INY2 M31B

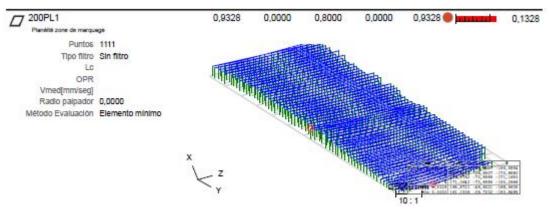
CAMBIAR PN

2042L2				0.2355
118.9355 loc fond 2042 / Y	117.8000	118.7000	116.9000	1.1355

LIMPIAR ZANO EN EL MOLDE

3072L2				-0.2364
182.4636 loc face 3072 / X	183.3000	183.9000	182.7000	-0.8364
loc lace 30727 A
